**SLIDE-OUTS**

# INNER TUBE ASSEMBLY REVISION ON THROUGH FRAME SLIDE-OUTS

TI-184

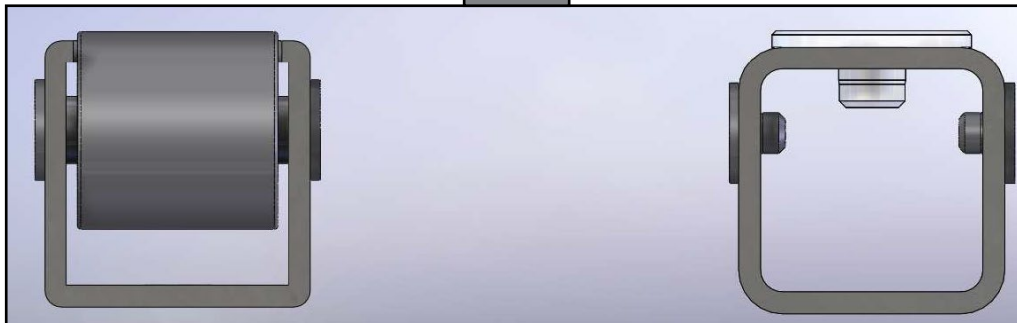
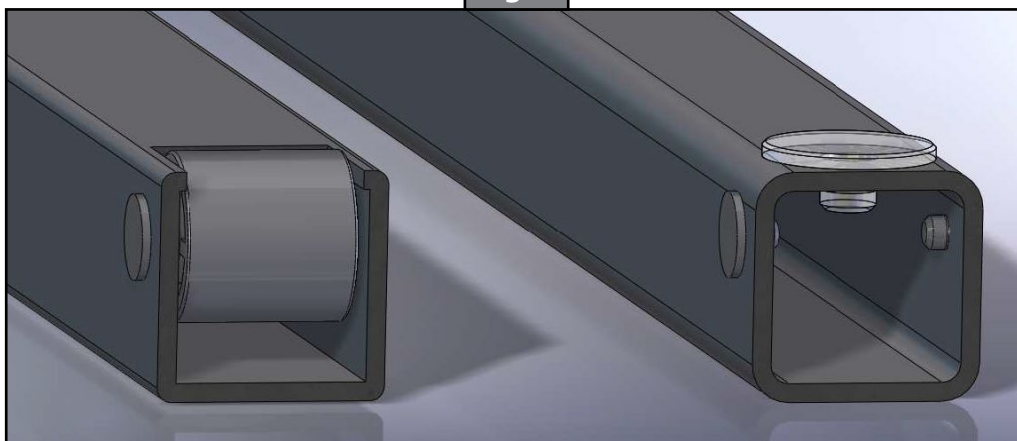
A revision has been made to the Inner Tube Assembly on Through Frame Slide-outs. The Rear Roller ([104475](#)) and Roller Shaft ([105893](#)) have been removed and replaced with a Wear Tab ([277882](#)). These new Inner Tube Assemblies are 100% interchangeable with the former design. This change was made to reduce noise created by the Rear Roller. See the illustrations below. See Page 2 for a part number comparison chart between the old version and new version.

Old version with Rear Roller ([104475](#)), Roller Shaft ([105893](#)), and Inner Tube Assembly (See Page 2)

New version with Wear Tab ([277882](#)) and Inner Tube Assembly (See Page 2)
